**RE: Draft Plan of Subdivision, Southwell Homes
Notice of a Complete Application for a Draft Plan of Subdivision Part
of Lot 4, Concession 10, and Lot 7, Registered Plan 288, geographic
Township of Ramsay, Municipality of Mississippi Mills, County of
Lanark,
County of Lanark File No. 09-T-22006**

**Re: First Submission Comment Letter – Plan of Subdivision
09-T-22006 Southwell Homes
122 Old Mill Lane, Appleton**

APPLETON SHORES SUBDIVISION

DRAFT PLAN OF SUBDIVISION
OF PART OF
LOT 4, CONCESSION 10
AND
LOT 7, REGISTERED PLAN 288
GEOGRAPHIC TOWNSHIP OF RAMSAY
MUNICIPALITY OF MISSISSIPPI MILLS
COUNTY OF LANARK
SCALE 1:1000 metres

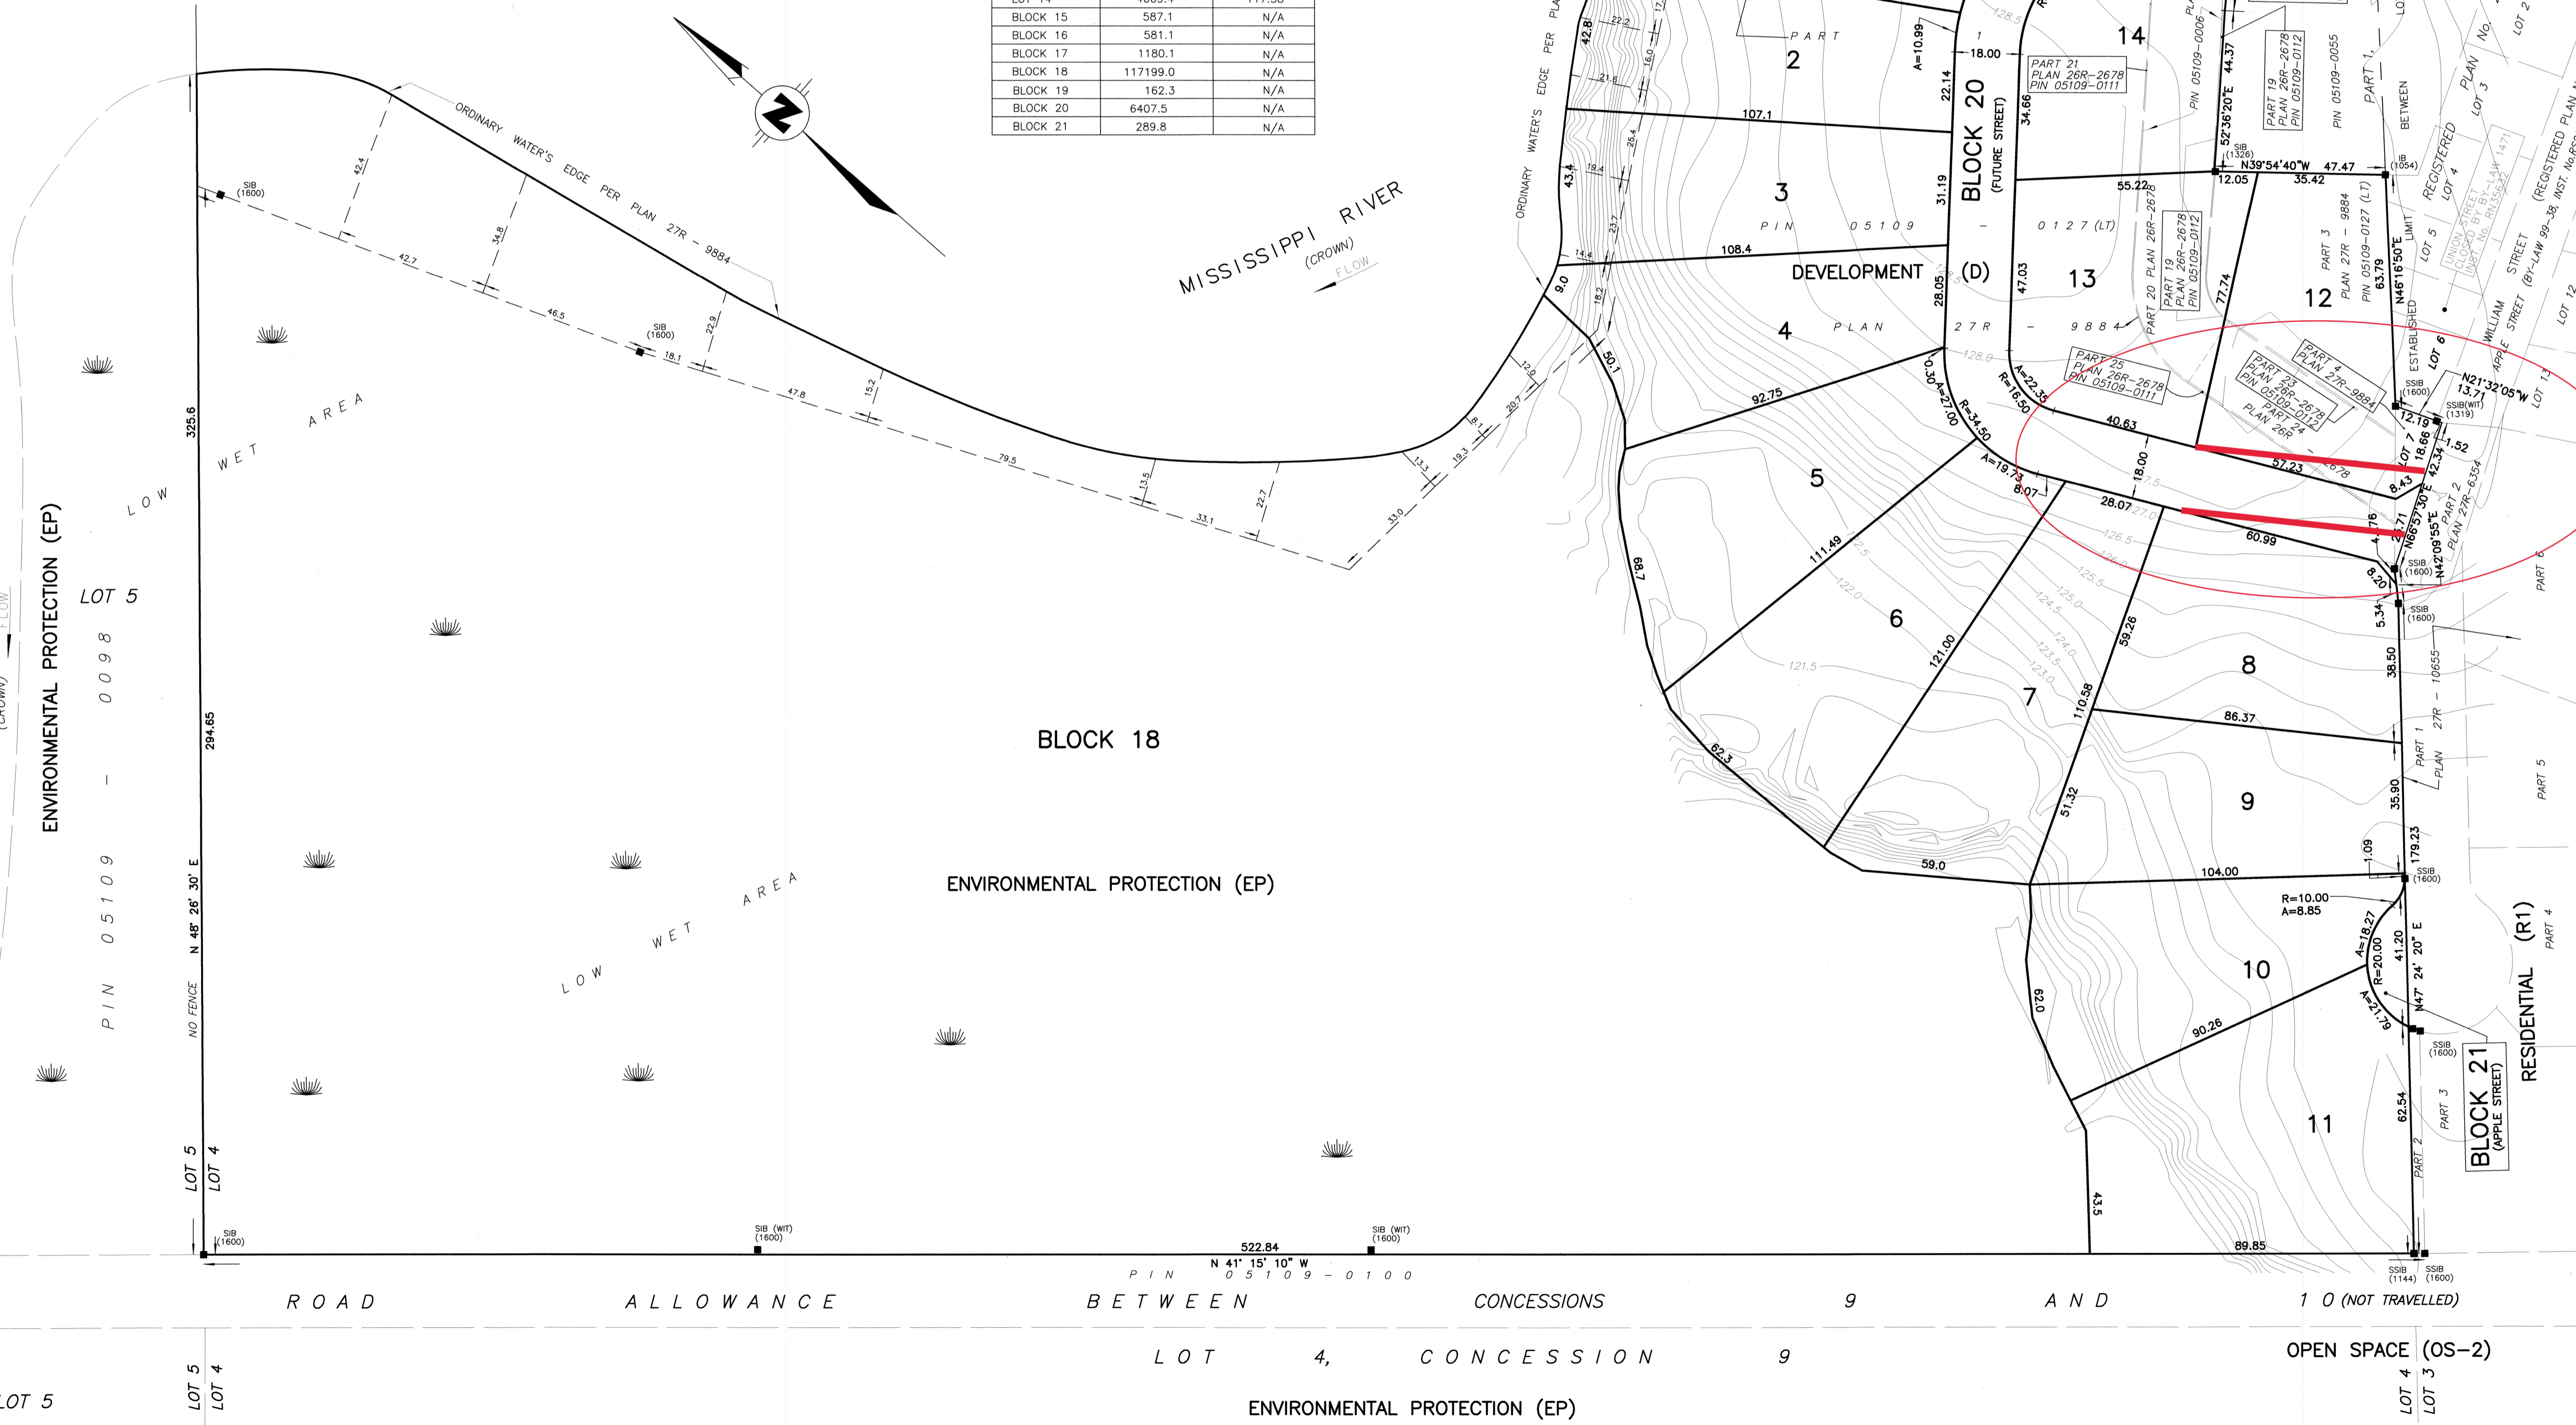
2. The Draft Plan indicates that Blocks 16 and 17 are Proposed Park Land; however, the Land Use Table indicates that Block 16 is a proposed addition to abutting parties. Please refer to attached plan provide clarification.

8. As noted on the attached plan, please remove the redundant area of Lot 14 abutting the existing residential lot at 124 Wilson St. This can be achieved by realigning Block 20 (future street), include this redundant area as part of Block 20 or consider conveying the redundant area to the owner of 124 Wilson St.

Remove redundant land from Lot 14 - either realign ROW to abut existing lot or convey this area as part of the ROW

SOUTHWELL HOMES LTD.
PHASE II - ENVIRONMENTAL SITE ASSESSMENT
 116-122 OLD MILL LANE
 APPLETON, ONTARIO
TEST HOLE LOCATION PLAN

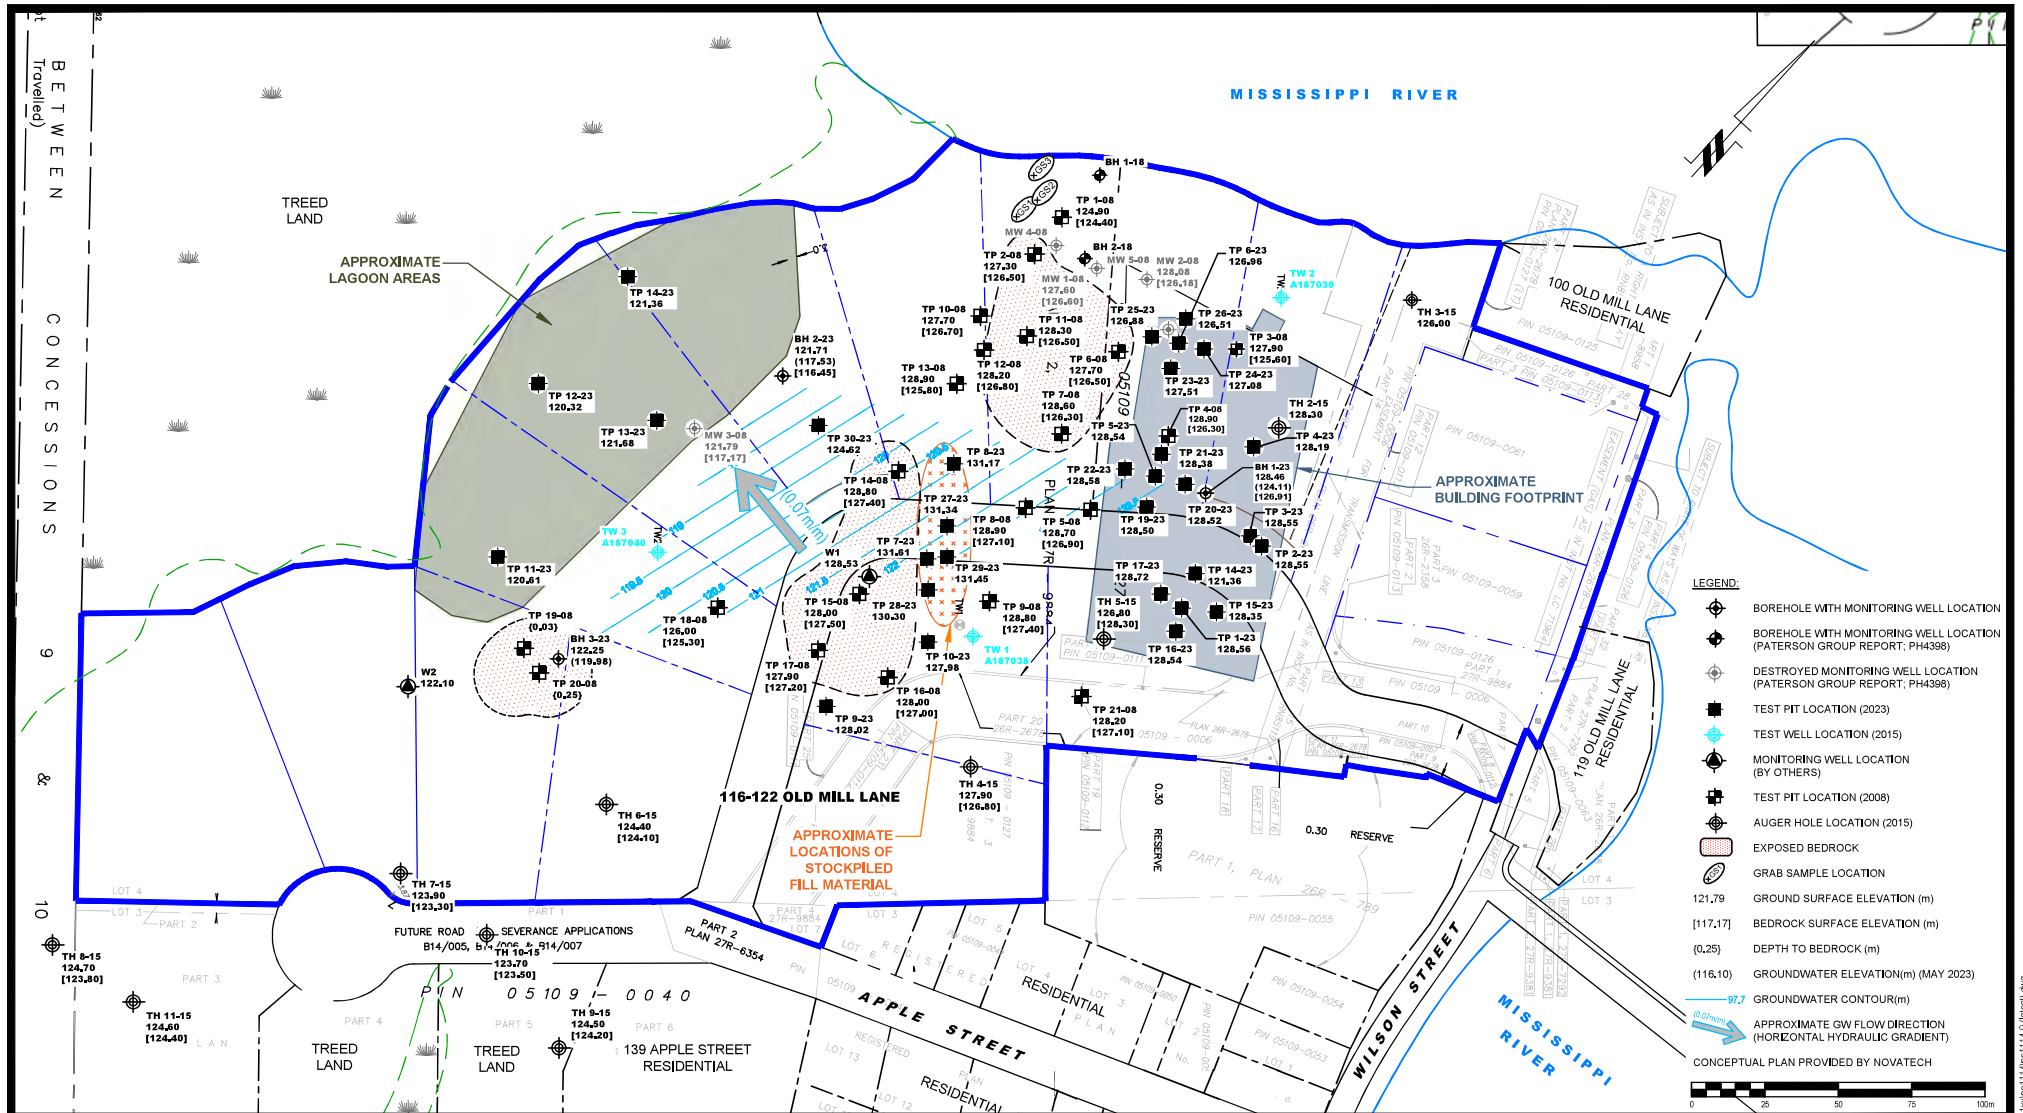
The westerly groundwater flow interpretation on Drawing No. PE1114-8 in the 2023 Paterson report appears to have used only the groundwater elevations for BH1-23, BH2-23 and BH3-23 for May 2023; however, the groundwater elevations in Table 4 of the 2023 Paterson report included wells BH1-18, BH2-18, TW1, TW2 and TW3. Since BH2-18 and TW3 appear to be installed at generally similar depths to the 2023 wells, Stantec considers that these could be included in the flow assessment. When these wells are included, Stantec interprets that the westerly flow is consistent, although the higher groundwater elevation at BH2-18 appears to reflect groundwater mounding within the former PHC remediation area where a bedrock trench was excavated.

- **Drawing PE1114-8** – Present all measured groundwater elevations from May 2023 on the groundwater flow drawing.
- **Drawing PE1114-9** – TP28-23-G2 the value for fluoranthene should be 2.42 ug/g instead of 1.04 ug/g.
- **Tables 1b to 4b** – These are labeled Soil but should instead be Groundwater.
- **Appendix 1** – Analytical Test Results: add a column to show the Table 8 values because some locations are compared to Table 8 in the text and figures.

ANALYTICAL TESTING PLAN (SOIL)

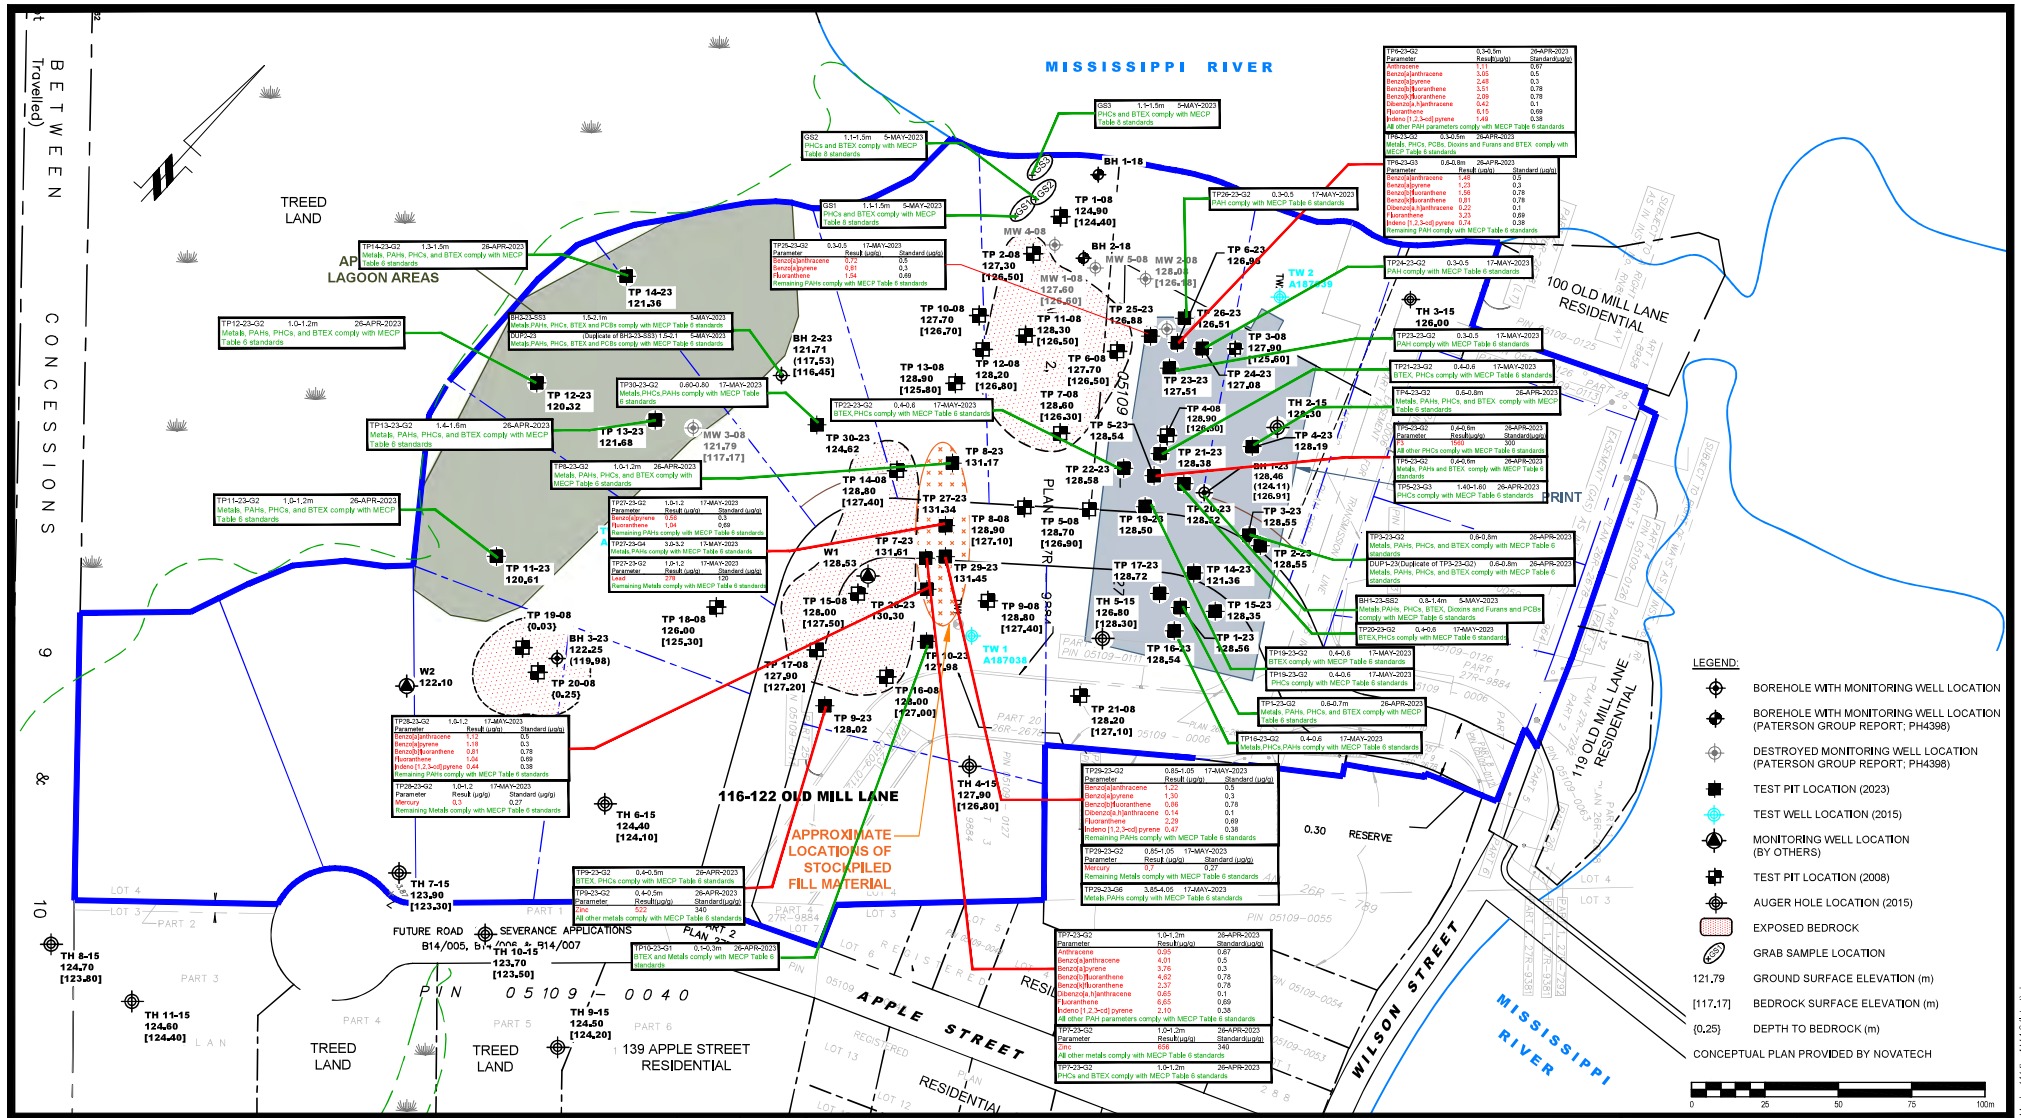
- **Drawings PE1114-8, PE1114-9, PE1114-10** – Add the area of former PHC Remediation (shown in green in previous test hole location plan, and on the drawing in the 2010 remediation report).
